## Review Comments

**Project:** Brighton Recovery Campus-Building B  
**Project No:** 20160686

**From:** Jason Worthen  
**Date:** March 20, 2017

### BUILDING B RESPONSES

EP1 | 1B

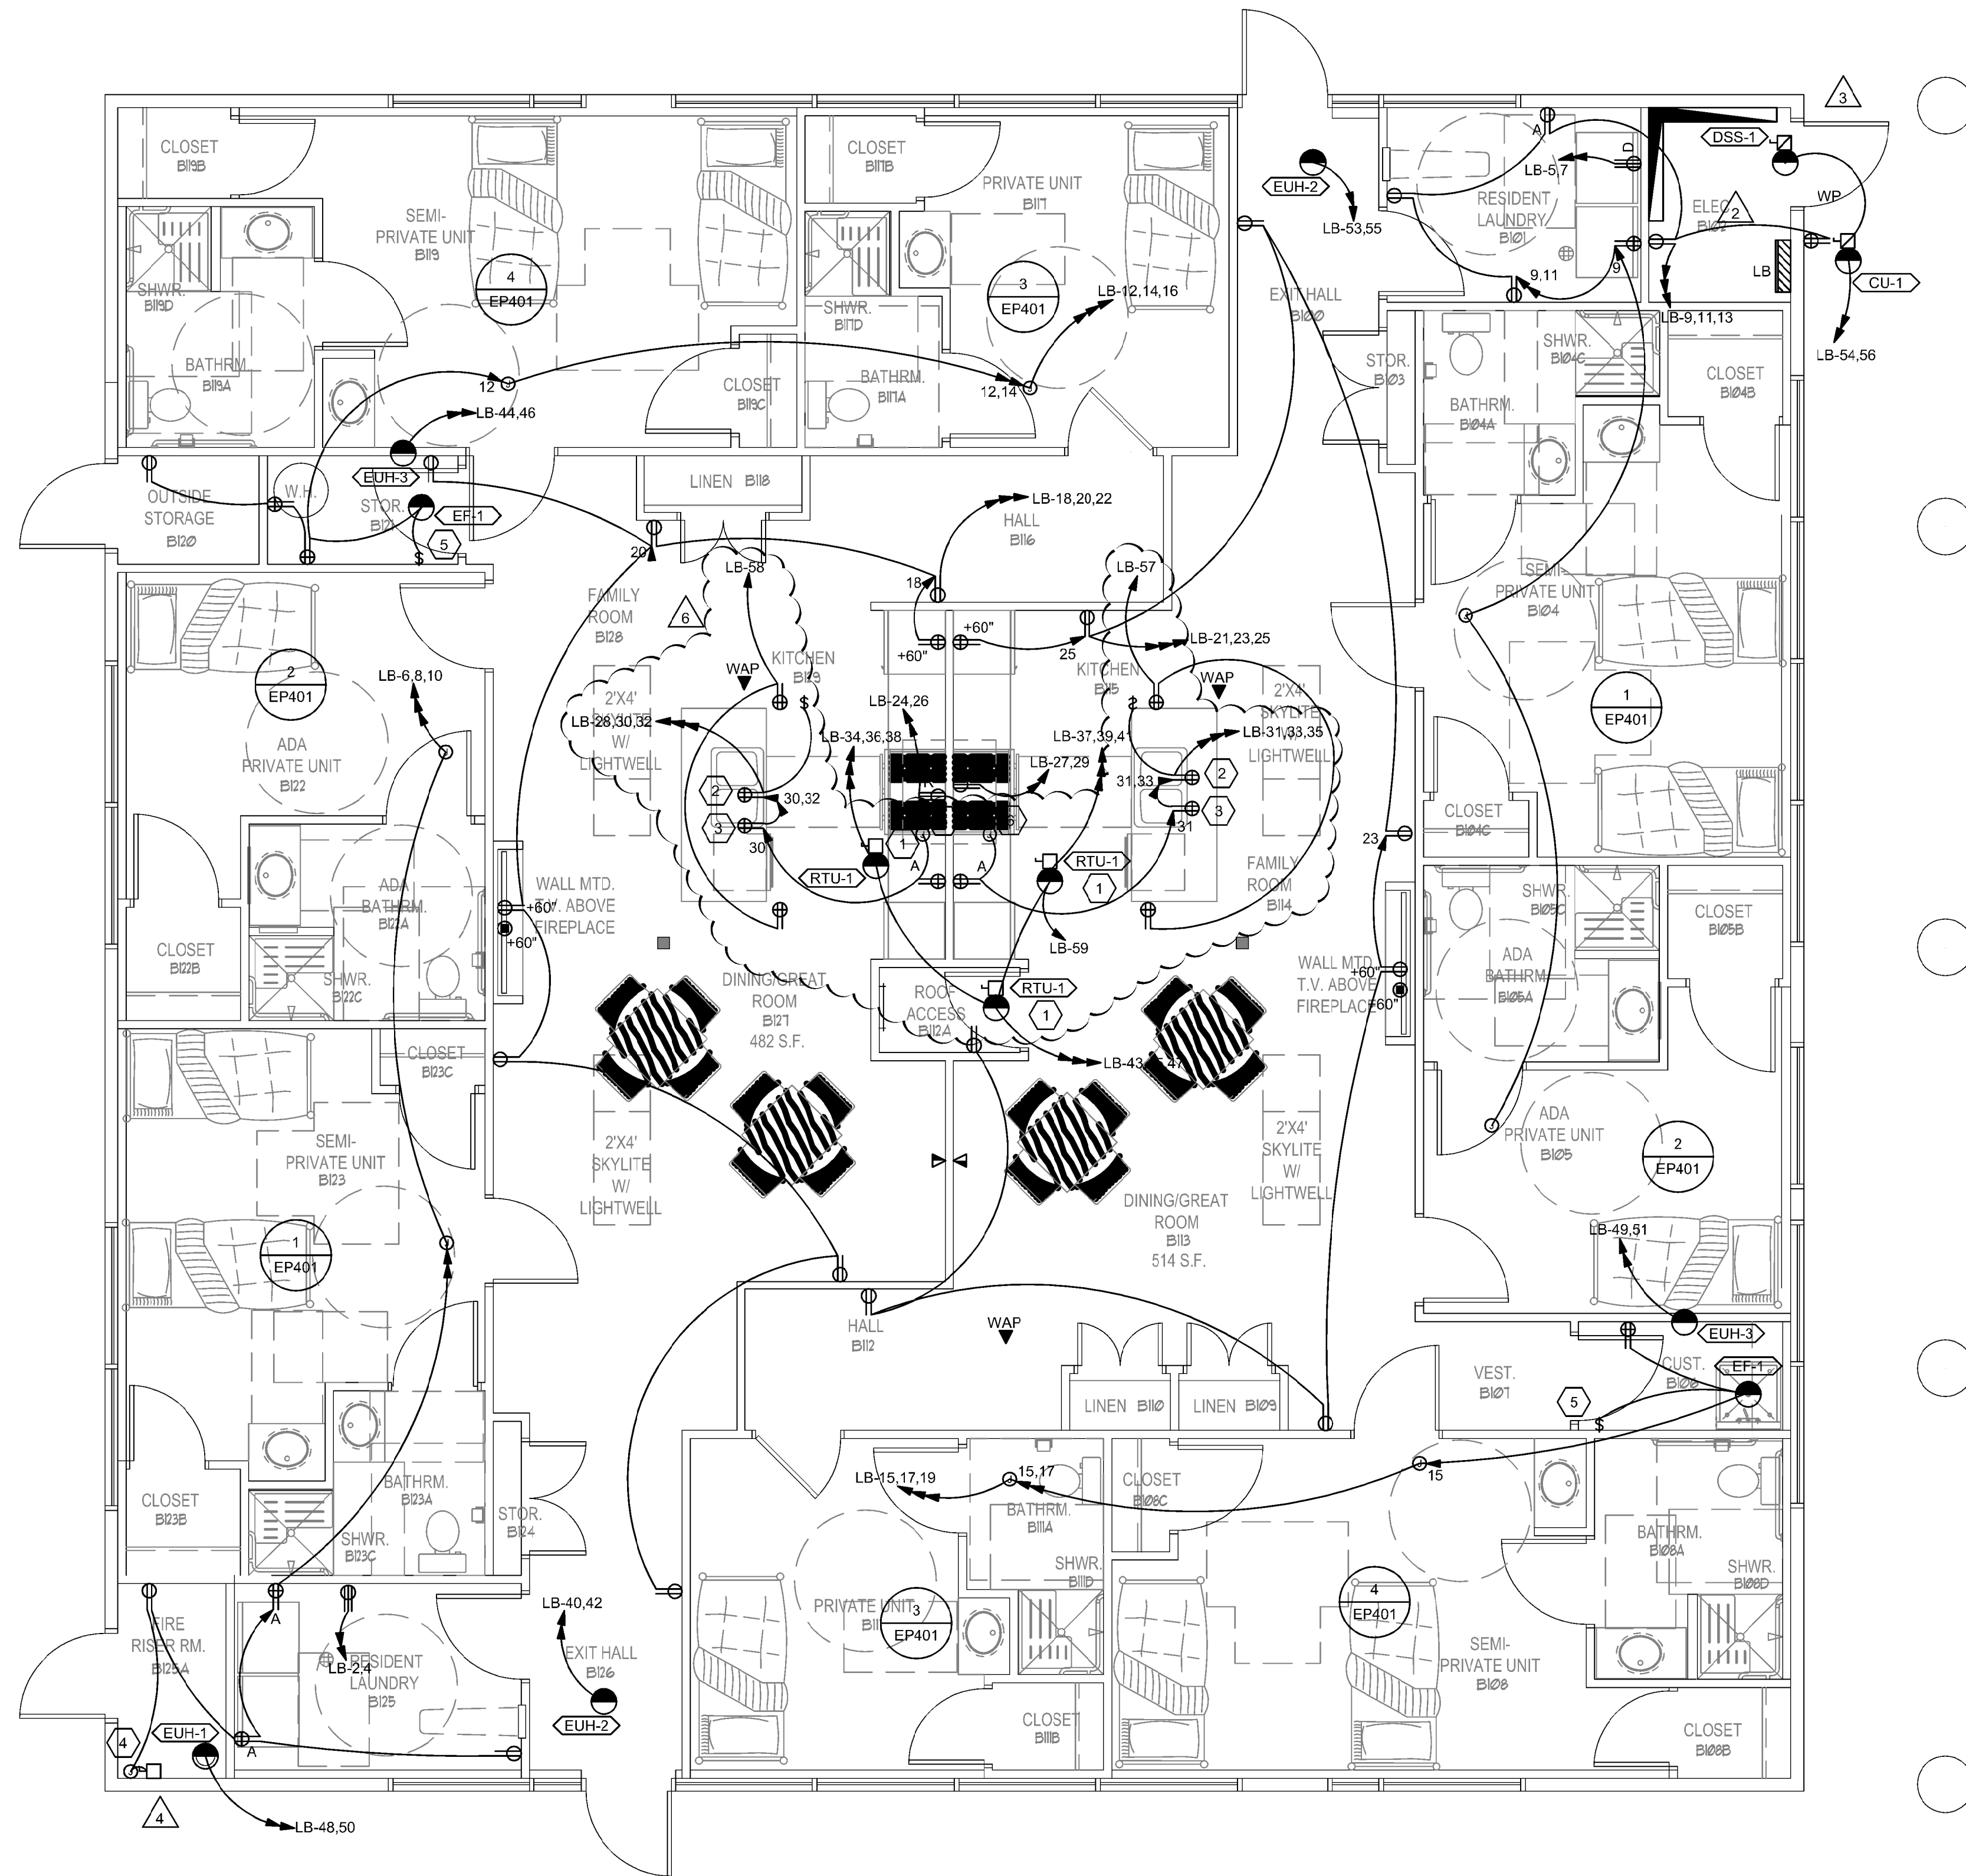
E4. Please note that tamper resistant receptacles are required. NEC 410.12A

E5. Please note that Arc-Fault Circuit interrupters are required in guest suites. NEC 210-12

E11. Sheet EP11B: Please address the following:

A. Receptacles shall be located for use on kitchen island.

B. Receptacle outlets within kitchen shall be GFCI protected.

C. Dishwasher shall be GFCI protected.

E12. Please coordinate with the Architect for the hood requirements for the range. There seems to be none addressed.

Response: Added a general note that all receptacles are to be tamper resistant to sheets EP11B and EP401.

Response: General note on sheet EP11B and EP401 requires that all circuits feeding 15 amp or 20 amp receptacles must be protected by an AFCI type circuit breaker.

Response: Added two duplex receptacles to each kitchen island.

Response: Changed receptacles in the kitchen to GFCI receptacles.

Response: Changed electrical connections for dishwasher and garbage disposal to be GFCI duplex receptacles.

Response: Added circuiting for range hood.

1. Added a general note requiring all receptacles to be tamper resistant.
2. Changed two duplex receptacles in the kitchen to be GFCI receptacles.
3. Added a 120V circuit for range hood.
4. Added one 120V circuit for receptacles provided with roof top units and modified key note #1.
5. Added two duplex receptacles to each kitchen island.
6. Changed the electrical connections for the garbage disposal and the dishwasher to be dedicated GFCI receptacles.

EP401

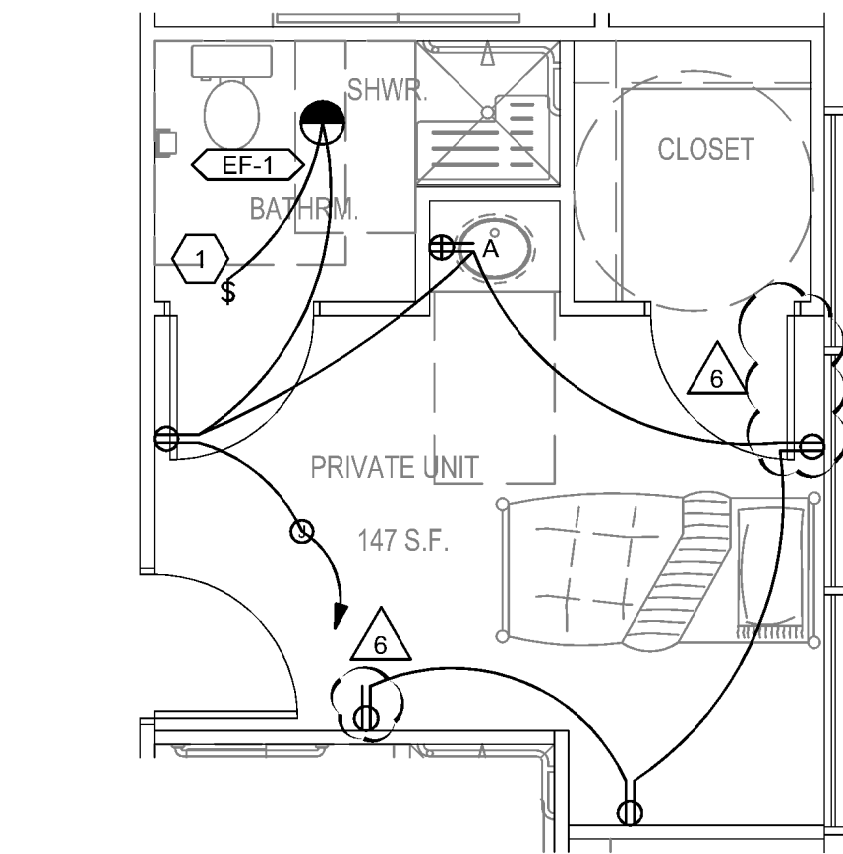
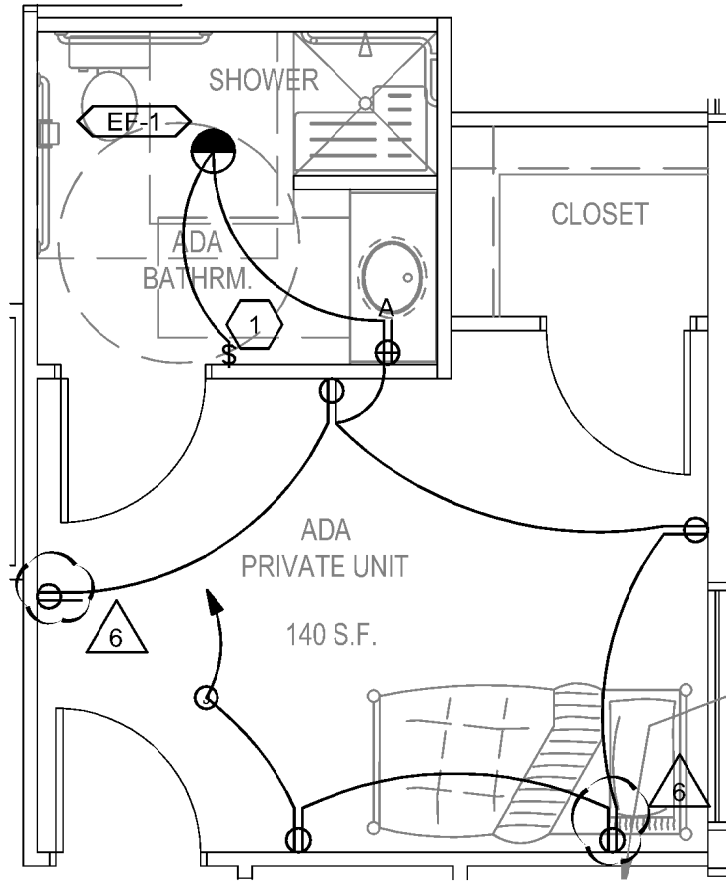
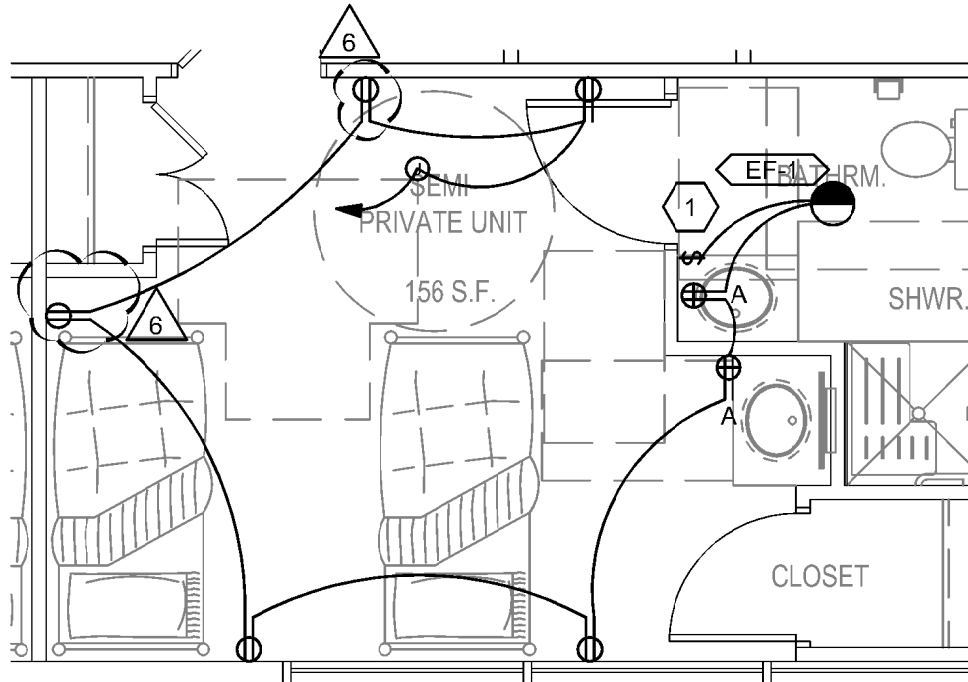
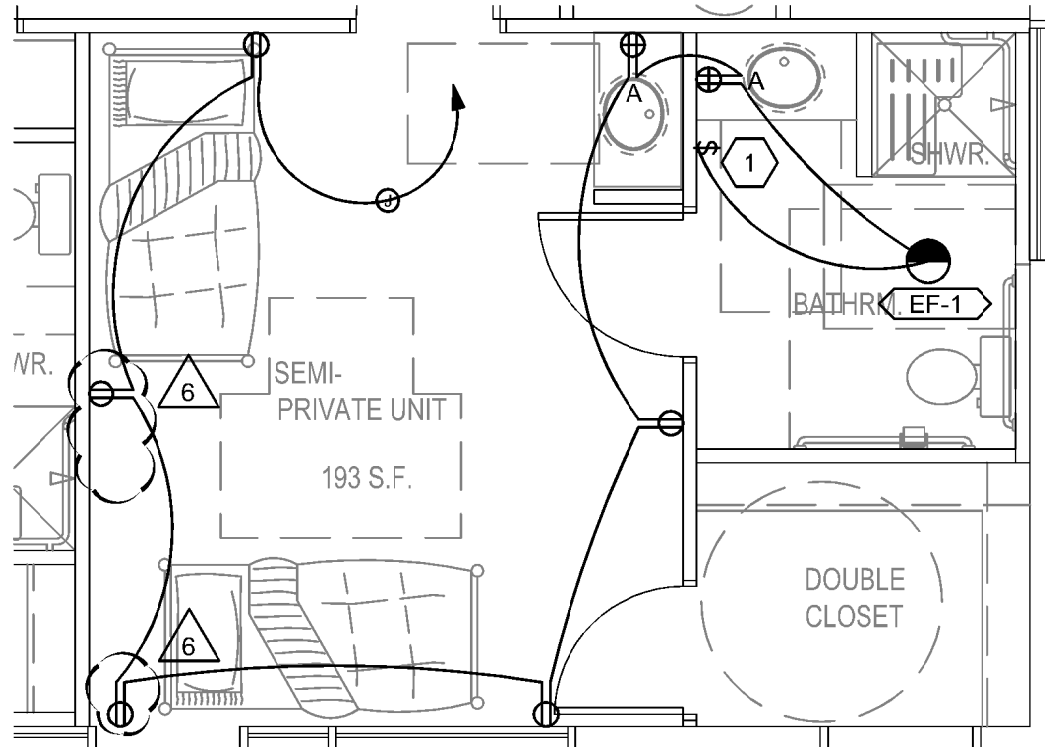
E6. Sheet EP401: Please address the following: Receptacle outlet spacing in guest, rooms, guest suites, and similar occupancies shall conform to NEC Article 210.60A.

Response: Details 1,3&4: Relocated one receptacle and added one receptacle in order to meet spacing requirements. Details 2: Relocated one receptacle and added two receptacles in order to meet spacing requirements.

1. Added a general note requiring all receptacles to be tamper resistant.
2. Detail 1:
  - a. Moved duplex receptacle near closet door to the outer wall.
  - b. Added a duplex receptacle on the bottom wall.
3. Detail 2:
  - a. Added one duplex receptacle on the top wall.
  - b. Relocated duplex receptacle on the wall shared with the closet to the left wall.
4. Detail 4:

- a. Moved duplex receptacle on the left wall at the foot of the bed closer to the bed.
- b. Added a duplex receptacle on the bottom wall.

EP601

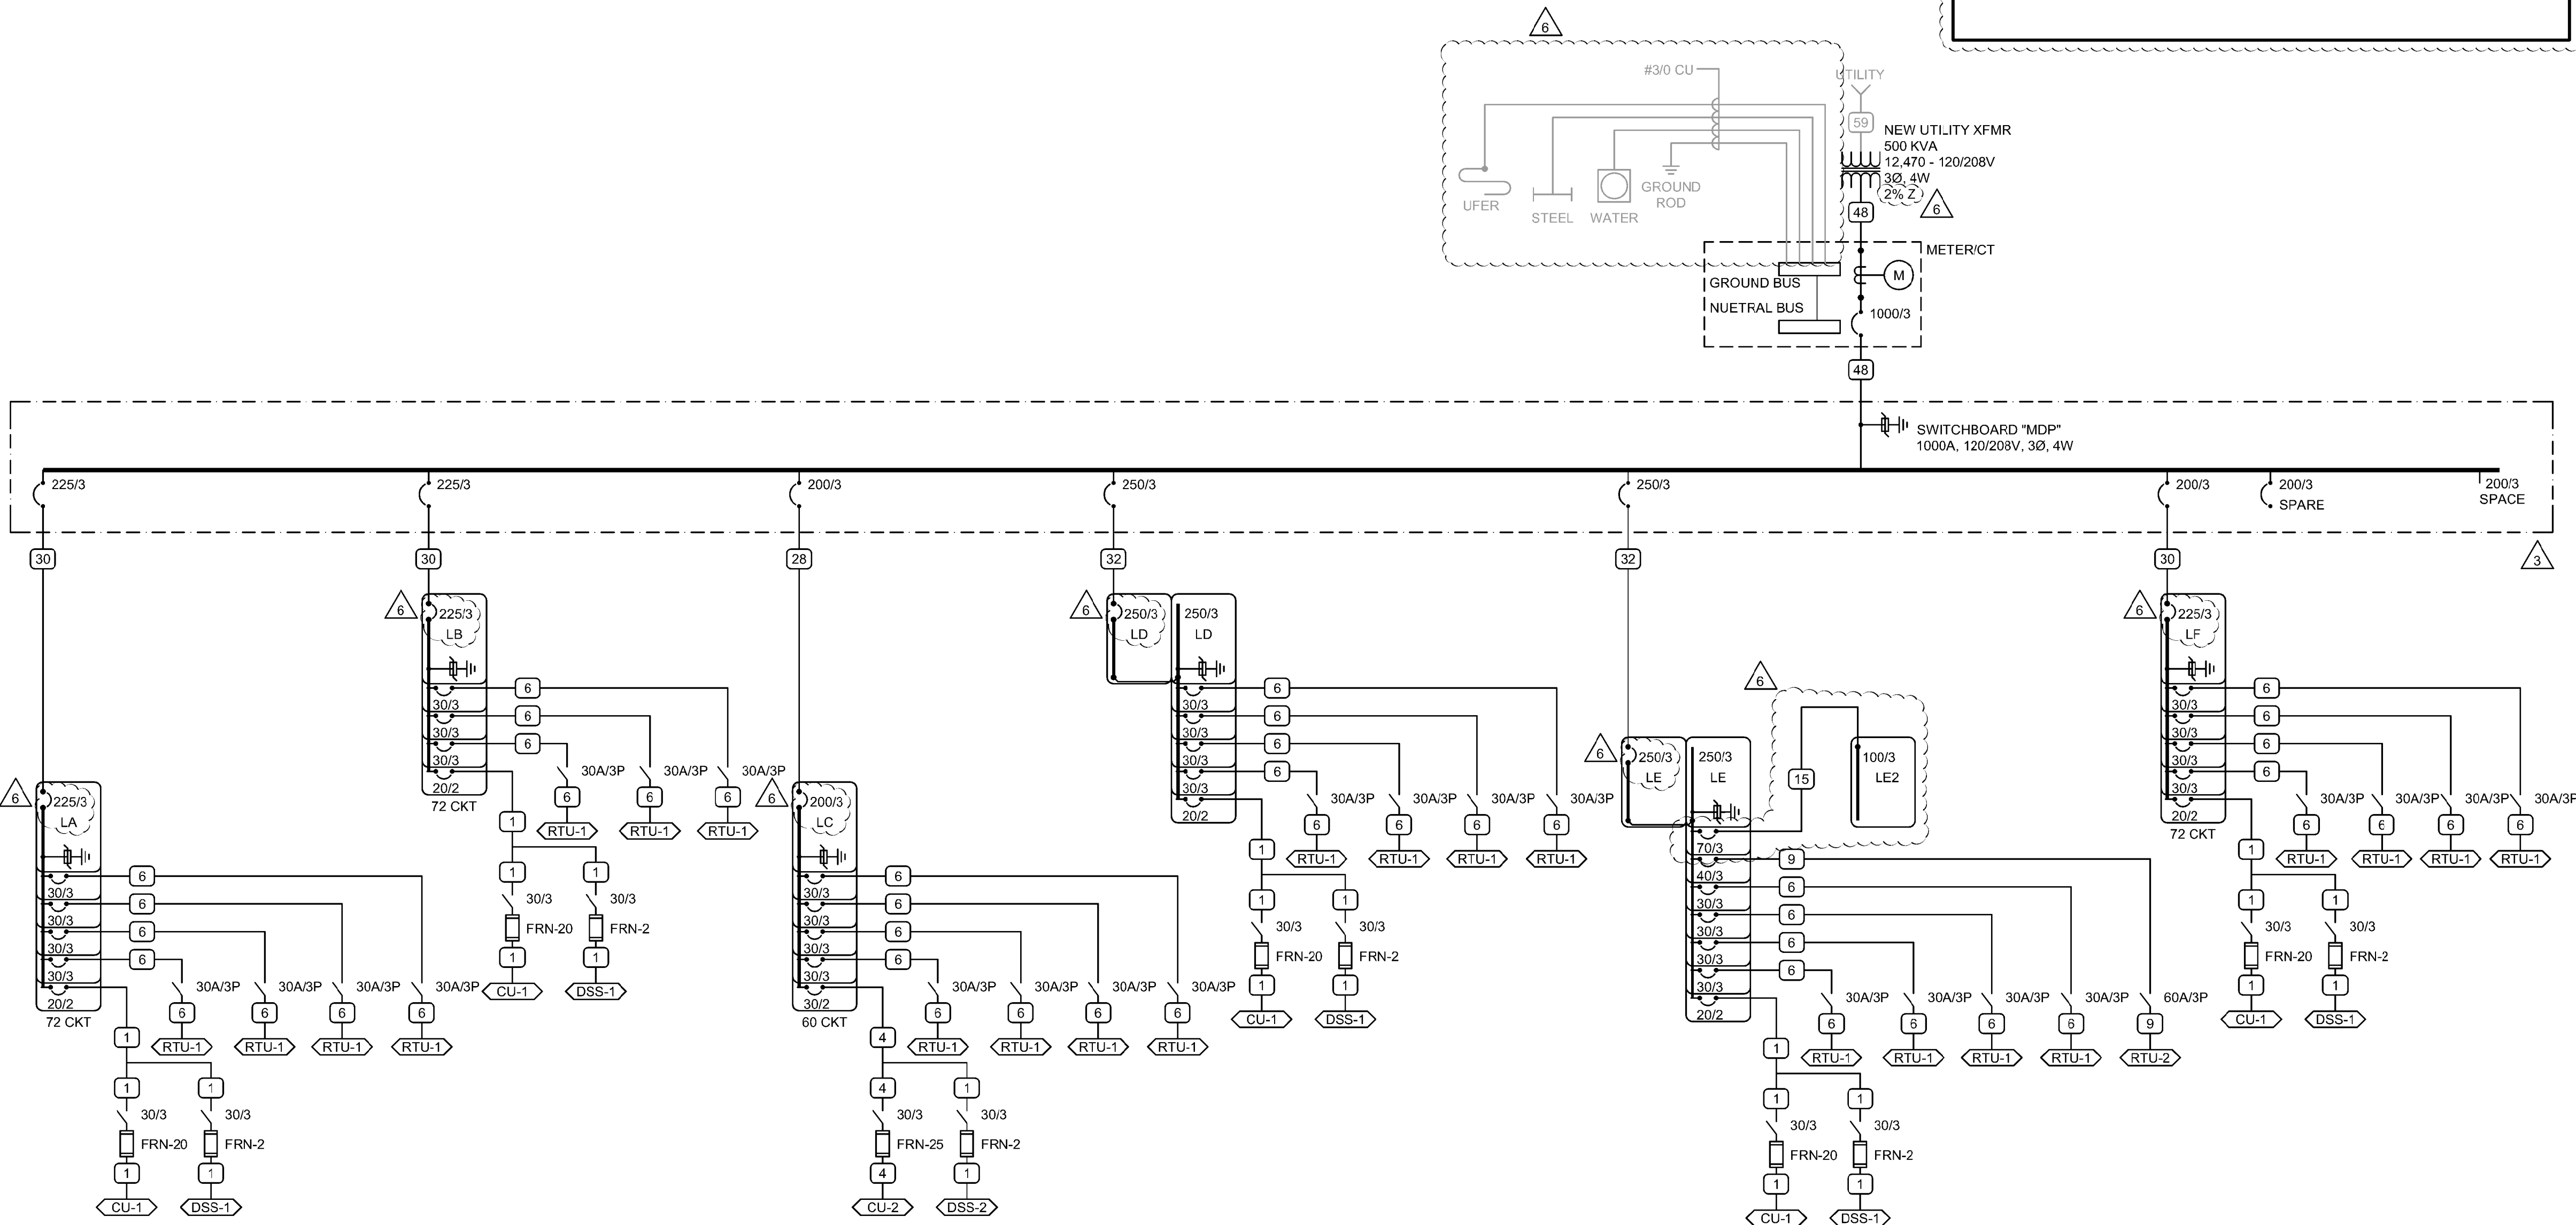
E8. Sheet EP601: Please note and verify location of the concrete encased grounding electrode.

E10. Please provide complete and detailed available fault current calculations (in accordance with NEC 110.9 and 110.10) and show the following on the plans:

Response: Modified grounding electrode circuiting on one-line diagram (EP601) instructing the contractor to connect the new services ground bus to the building existing grounding electrode system.

If there is an existing UFER system, the new service will be connected to it. However, a new UFER grounding electrode will not be installed.

Response: Added impedance of the utility transformer to one-line diagram. KVA rating is already shown.

Response: This information is shown in the fault current table on EP601.

Response: Added general note to EP601 calling for all overcurrent protective devices to have the same AIC rating as the panel or gear they are located within.

Response: Added a general note to EP601 requiring that all electrical equipment be field marked with the calculated available fault current.

1. Added impedance for the transformer that was used for fault current calculations.
2. Added general note calling for all overcurrent protective devices to have the same AIC rating as the panel or gear they are located within.
3. Added a general note requiring that all electrical equipment be field marked with the calculated available fault current.
4. Changed one-line diagram to shown the grounding electrodes as existing.
5. Changed all branch circuit panels from main lugs only to main circuit breaker panels.
6. Added panel LE2.
